CRAFT STATE OFFICE BUILDING ROOF REPLACEMENT

Addendum 2

North Platte, Nebraska
1604

Date Issued: June 1, 2016
Ad. Date: June 16, 2016

Addendum 2 – 3 Sheet A4.0 Roof Plan

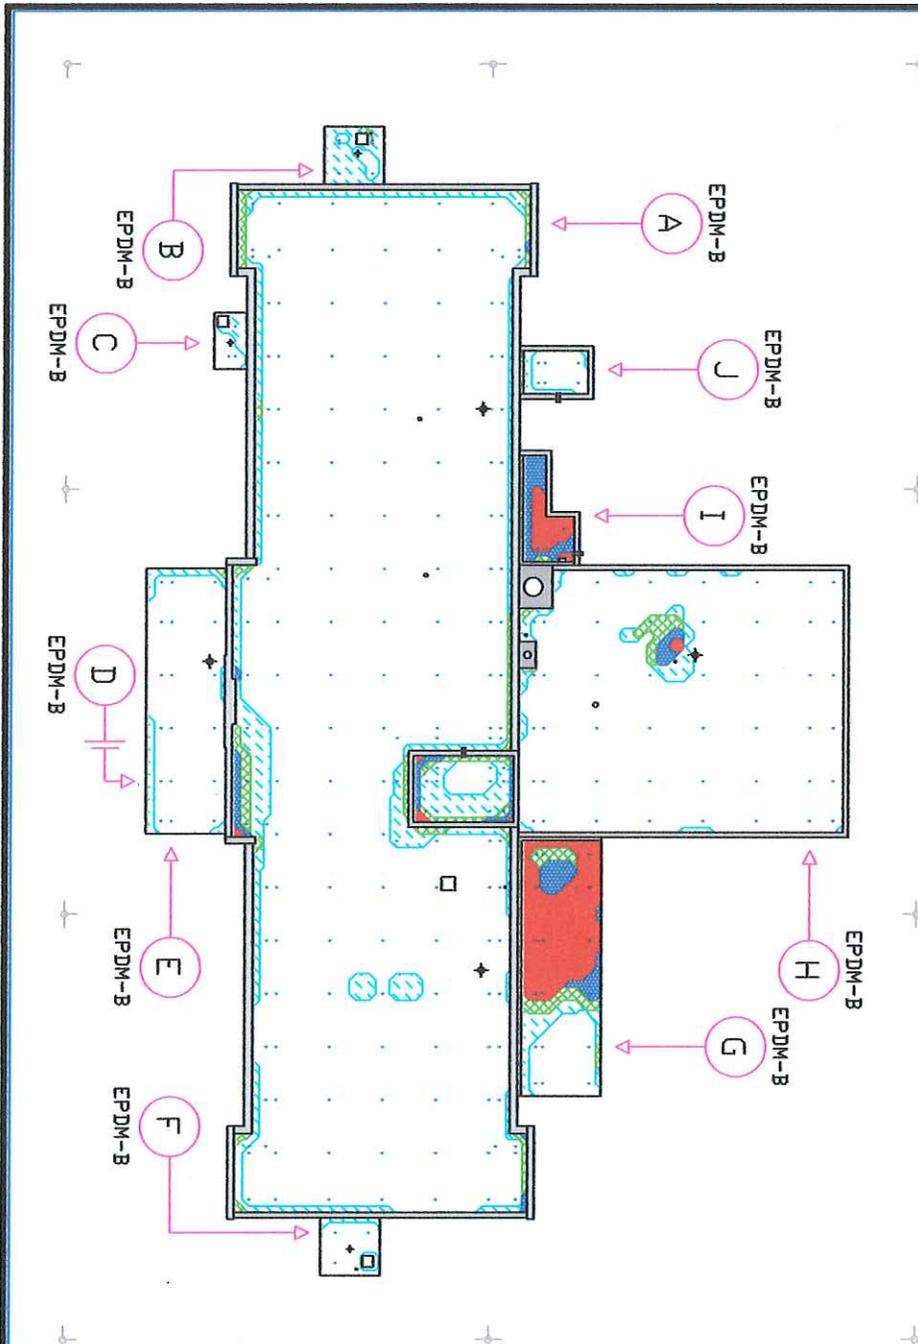
Remove note which currently reads: "EXISTING GUTTER AND DOWNSPOUT TO REMAIN". Replace with note to read: "EXISTING GUTTER AND DOWNSPOUT TO BE REMOVED AND REPLACED."

Add note to northwest roof (RA-3) and L-shaped roof on the southwest portion of building which reads: "REMOVE AND REPLACE EXISTING PLYWOOD DECKING IN ITS ENTIRETY. NEW DECKING SHALL BE 3/4" EXTERIOR RATED PLYWOOD. VERIFY IN FIELD, ANY DISCREPANCIES CONTACT ARCHITECT IMMEDIATELY."
